**THE CITY OF BOULDER
SPECIAL CITY COUNCIL MEETING
COUNCIL CHAMBERS, 1777 Broadway
Thursday, January 15, 2015
6 PM**

A. CONCEPT PLAN REVIEW AND COMMENT

AGENDA TITLE: CONCEPT PLAN REVIEW AND COMMENT: Request for public and Planning Board comment on a proposal for a redevelopment that includes a mix of uses including office, retail, restaurant, and multi-family residential apartments. Proposed are approximately 103,000 square feet of office, 12,000 square feet of retail/office "flex" space, 12,000 sf of retail/restaurant, and 242 residential units comprised of studio, one, two and three bedroom units along with live/work units. The development proposed would require a rezoning for the two areas of the property. This is the second Concept Plan review submitted for this project.

Project Name: Reve Pearl District
Location: 3000 Pearl Street; 2170, 2100 30th Street and 2120 32nd Place
Size of Tract: 6.01 Acres (186,676 square feet)
Zoning: Business Regional-1 (BR-1) and Industrial General (IG)
Comprehensive Plan: General Business (GB) on the south and Mixed Use Business (MUB) on the north.
Key Issues: Staff is recommending the following key issues for discussion of the Concept Plan:

Figure 15: Current Concept Above Compared to Original Concept Below

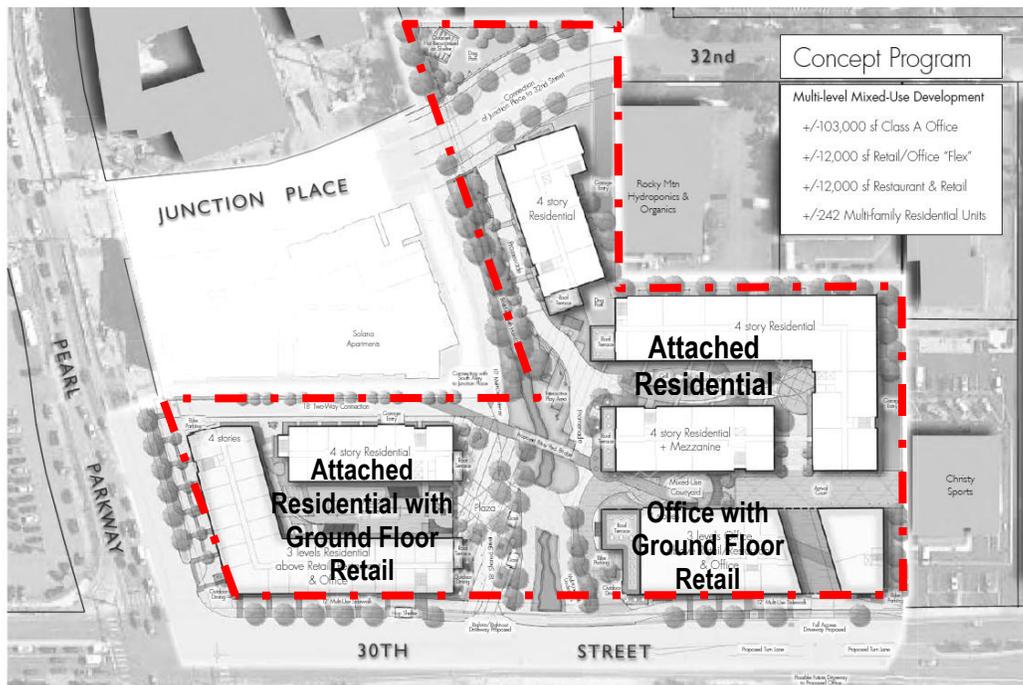
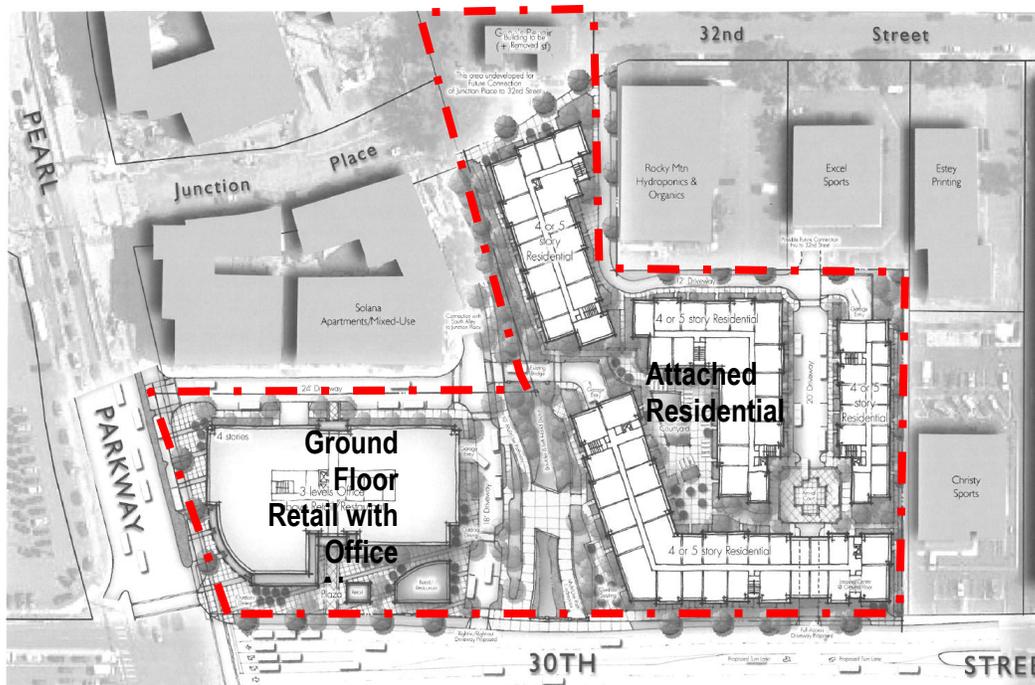
At the June, 5, 2014 Planning Board hearing, the board discussed several key issues regarding the original Concept Plan. The meeting minutes in their entirety are available at the following weblink: [June 5, 2014 PB Hearing Minutes](#). At the hearing, the Planning Board presented several suggestions to the applicant with regard the building and site design and recommended the applicant submit a second Concept Plan to address them. Among the key suggestions was to include residential over retail on the northwest corner to improve compatibility with the TVAP Guidelines. Below in Figure 15 is a comparison of the current concept plan with primarily residential and retail at the northeast corner and office fronting 30th Street on the south side of the site with residential behind; compared to the original concept plan with office at the corner of 30th and Pearl streets and all residential land uses on the south side of the site.

**Figure 23:
TVAP Connections Plan
Compared to the Concept Plan**

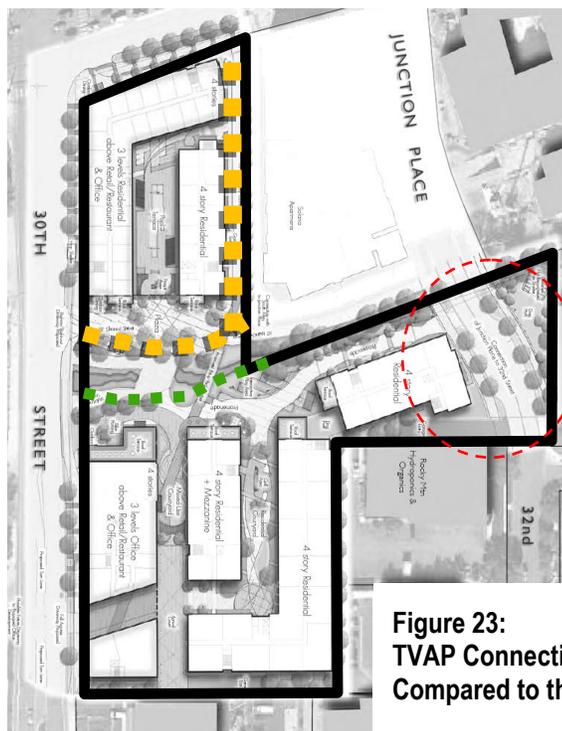
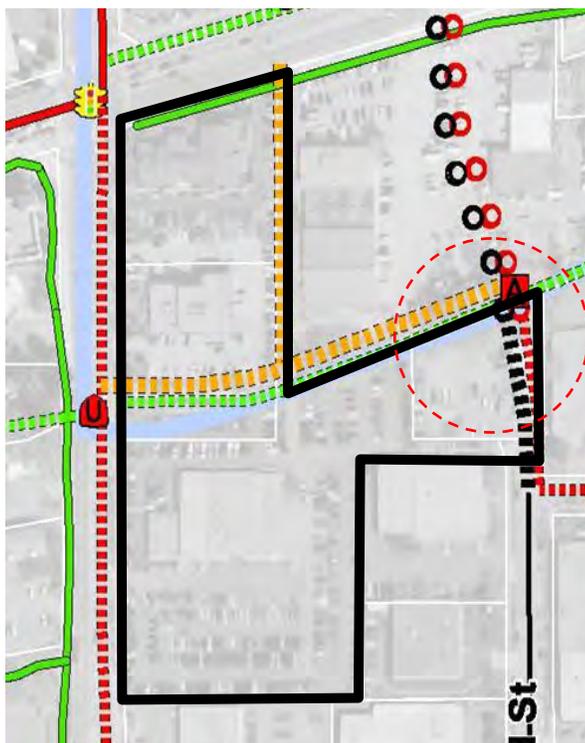
One of the Key Issues for discussion of Transportation Connections is the overall circulation plan for the site. Staff recommends access to the site be from a combination of a right-in, right-out at 30th Street on the north side of the ditch, a full movement access to 30th Street on the south side of the project that aligns with the proposed access point across the street and a full movement access with Junction Place / 32nd Street on the east side of the project. Another of the part of the circulation key issue is the lack of definitive illustration of the extension of Junction Place and the bridge connection over the ditch. This connection is shown on the TVAP connections plan with the symbol: **A** The applicant is illustrating the bridge connection. A comparison of the required connection and how comparable connections are shown on the concept plan is shown in Figure 23. The circle represents the location of the future bridge. It is important for this project to provide a clear connection to Junction Place, which then provides a clear path to both Pearl Parkway and the transit center that is currently under construction.

The proposed concept plan appears to meet the intent of other TVAP connections, in particular providing the local roadway connections shown within the site, albeit in configurations that may require amending the connections plan slightly. In the locations of the two local roadways shown on the site, the applicant is illustrating a roadway with on-street parking on the northeast side of the site. The center of the site, along the ditch, is illustrated as a shared street, or like a “wooner” where bikes and pedestrians are provided the space and autos are “guests.” The applicant illustrates how, on certain days, this space could accommodate food trucks to amenitize the space or create small food kiosks that would align the ditch and bike path, as shown below. This configuration is compelling and could meet the vision of TVAP, but would require a request to amend the TVAP Connections Plan in Site Review.

Figure 25a and b
Site Location with Natural Grade (above in 1958 USGS topo) compared to Altered Grade of today (below)

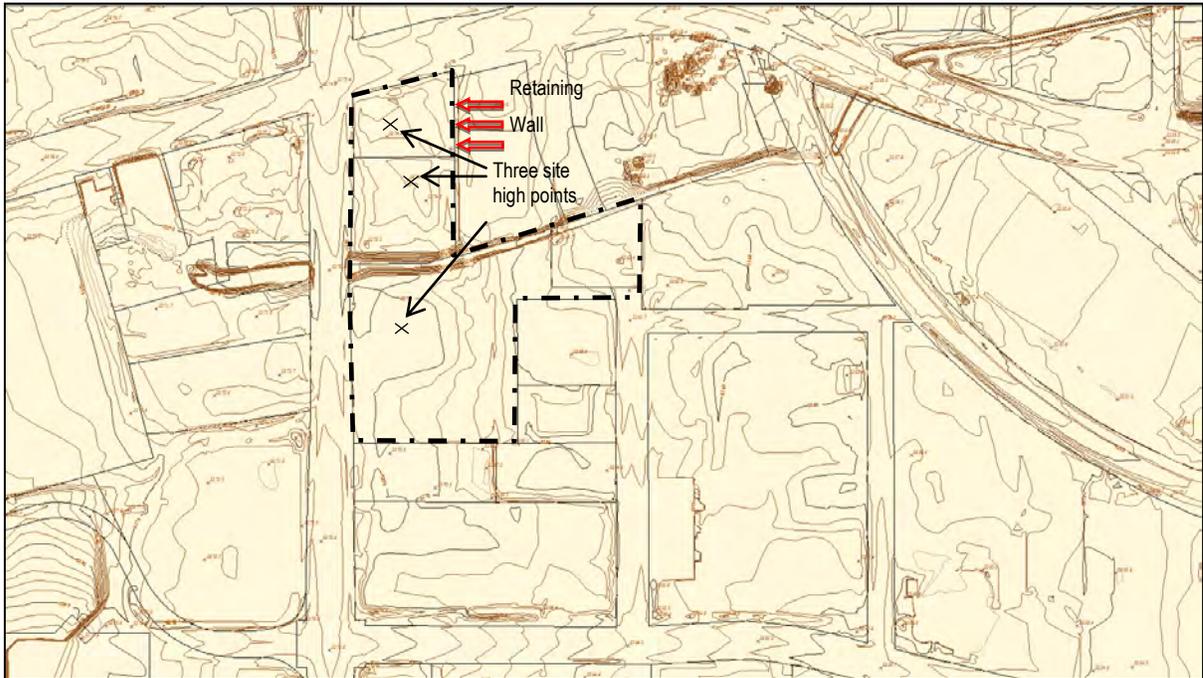
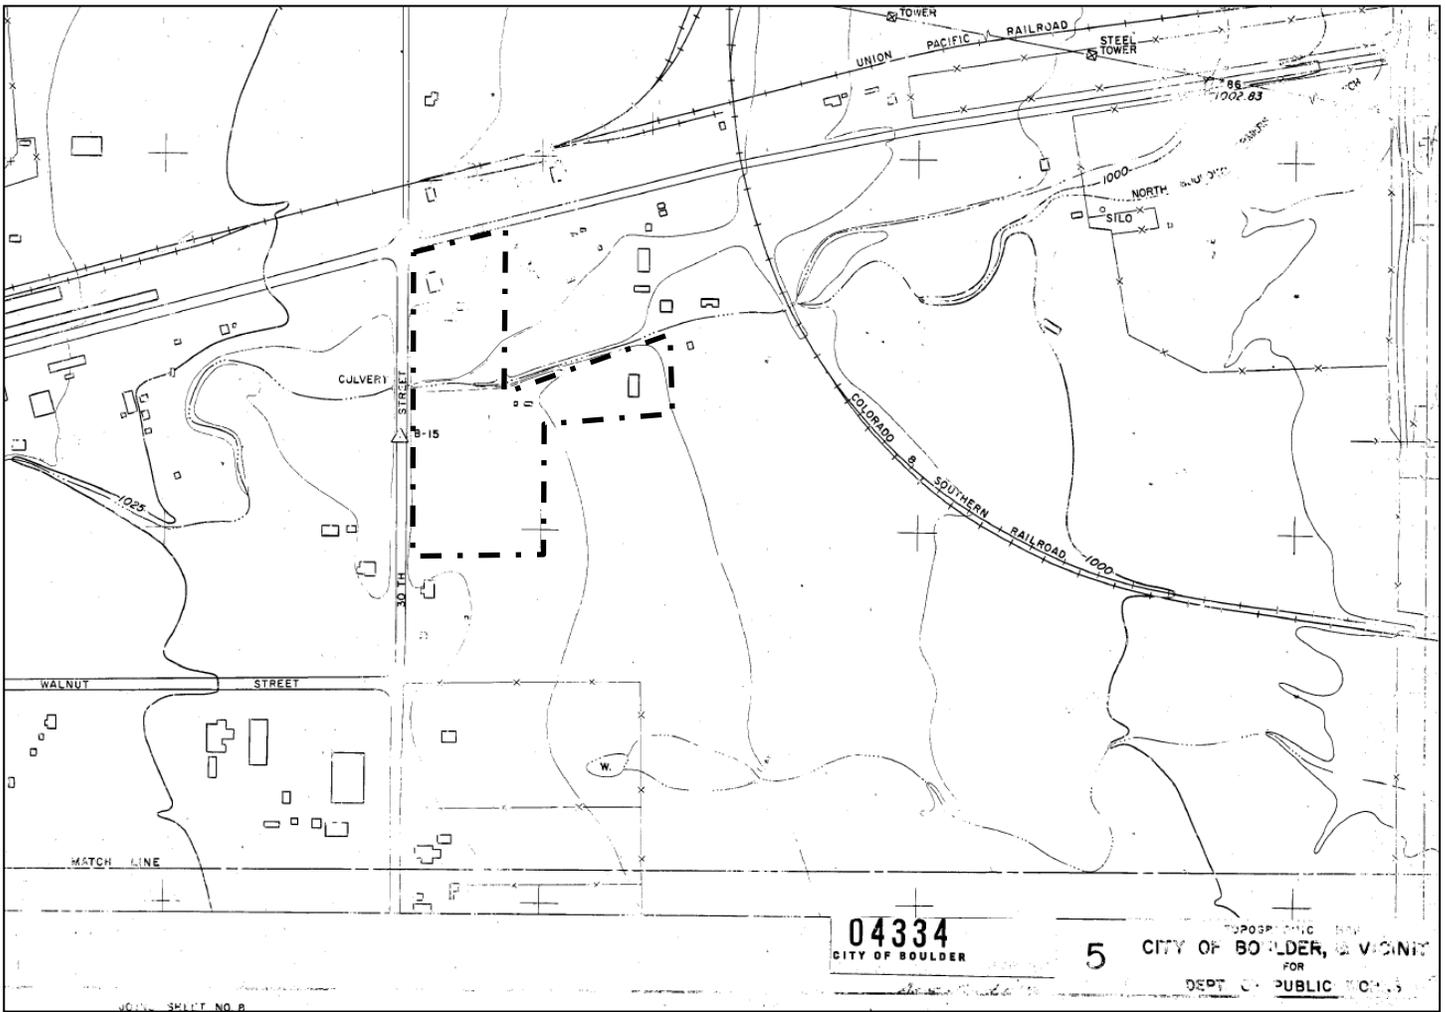
As noted in the previous Concept Plan, is the proposal to return the existing site’s altered topography back to the original grading, shown in Figure 25a from a 1958 USGS topographic map. As is understood, the site was altered a number of years ago with fill added to bank the site toward 30th Street and create an auto display area, as can be seen in the current topographic map in Figure 25b. The plan to remove the fill and retaining wall will help to bring to fruition, the proposed local access road at the east side of 3000 Pearl property as envisioned in TVAP. As shown in Figures 26a and 26b is the retaining wall on-site and where the wall is located in relation to the TVAP connections plan. The existing retaining wall usurps the opportunity to create the connection for both properties to use that connection without extraneous pavement. Prior to Site Review, the applicant and the adjoining property owner at Solana Apartments will be required to establish an agreement on how best to configure the access between the two properties, with city approval of that agreement.
